Convex Slope Determination

DATE: January 28, 2026
TO: Brandon Straus, Applicant
FROM: Alison Becker, AICP, Community Development Director
PREPARED BY: DeDe Tran, Assistant Planner
SUBJECT: 333 26th Street- Convex Slope Determination, Findings Not Met

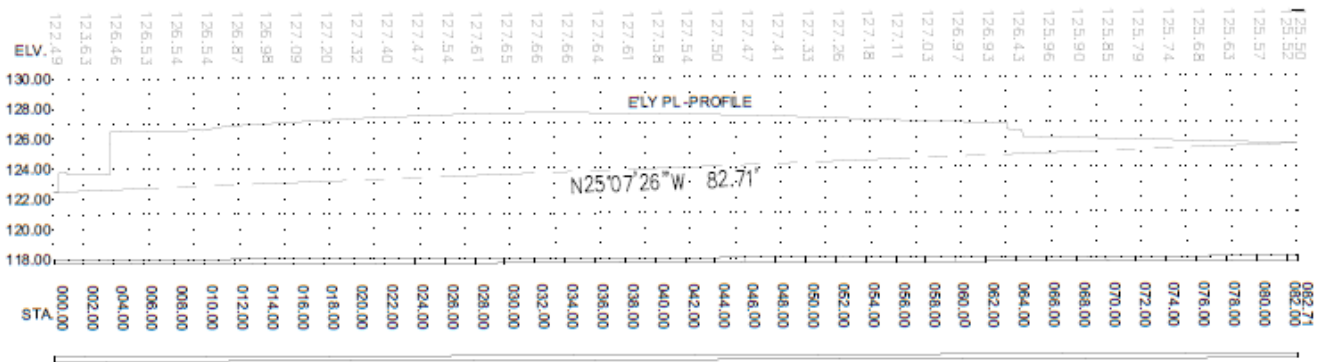
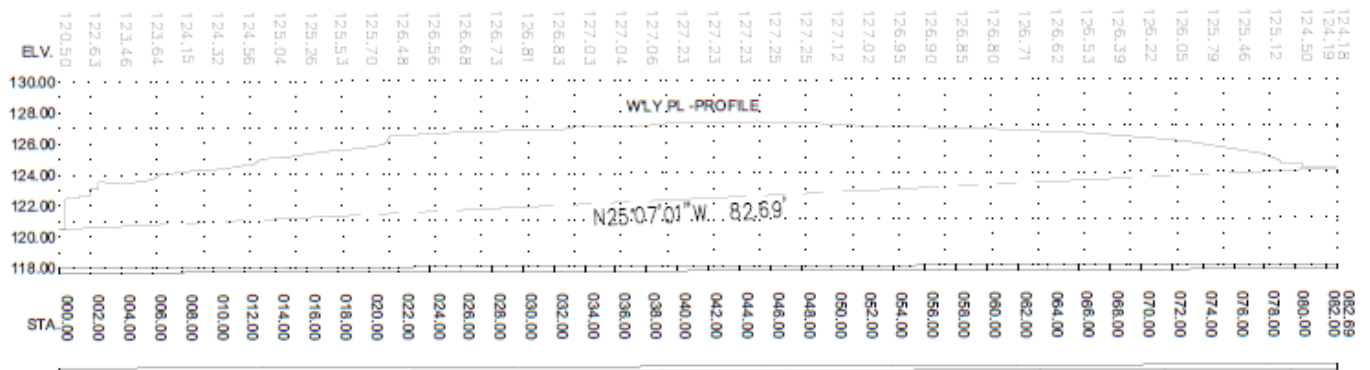
An application for a Convex Slope Determination (CSD25-04) at 333 26th Street was submitted on December 2, 2025, by the applicant. The application included a survey with two-foot intervals, and a Soils Report with seven boring samples located across the property. The first three borings are at the southern portion of the lot along 26th street at the property corners and about one-third across the lot, closer to the northwest property corner. There are an additional two borings in approximately the middle of the lot along the property lines, with the final two borings located at the rear of the lot, close to the property corners, as shown in the submitted geotechnical site plan below. The fill depth was noted in the table alongside the site plan.

The property corners have the following elevations per the applicant's submitted survey:

Southwest: 120.50
Southeast: 122.49

Northwest: 124.18
Northeast: 125.50

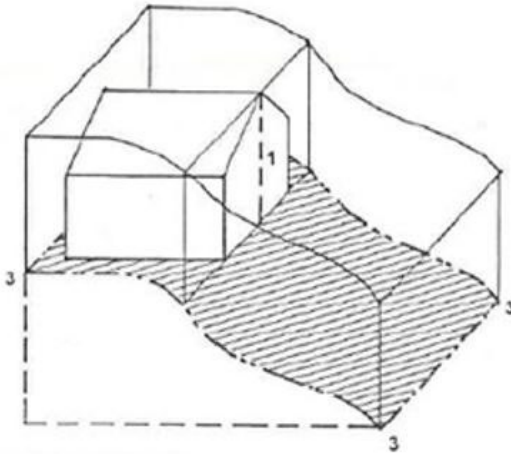
The survey below reflects the elevations at two-foot intervals.

The survey documents the property corners; the grade difference between the highest elevation (125.50 feet at the northeast corner) and lowest elevation (120 feet at the southwest corner) points is only a five-foot difference. The highest elevation documented on the two-foot topographical survey is 127.66 feet, near the middle of the property. The condition document does not reflect a qualifying convex-slope condition with an arch or rise along a property line. The figure below illustrates the kind of "arching" on an uneven, convex, variably sloping lot that is consistent with a convex lot. Additionally, the proposed redevelopment of this property would alter the existing grade conditions, eliminating the mid-lot slope.

UNEVEN/CONVEX OR VARIABLY SLOPING LOT

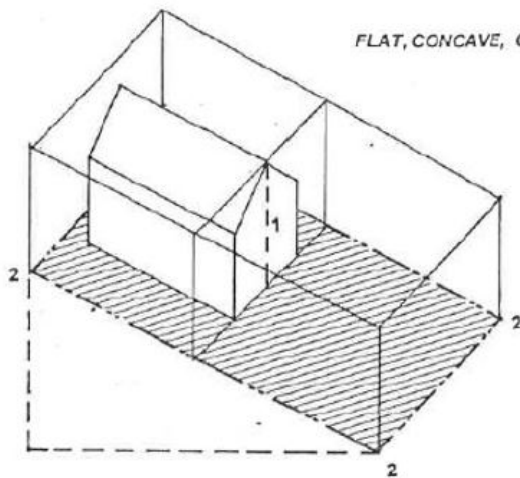
The evidence does not support a convex slope determination. The lot condition does not meet the characteristics of a convex lot as defined in the code, "where the ground level arches upward along a property line," as in those cases where there is a more significant elevation change reflected across the property corners, and which can be found in some portions of the city's naturally hilly topography. Additionally, the applicant proposes to alter the grade, eliminating the mid-lot slope. Therefore, additional height through a convex slope determination is not warranted based on the lot's topography.
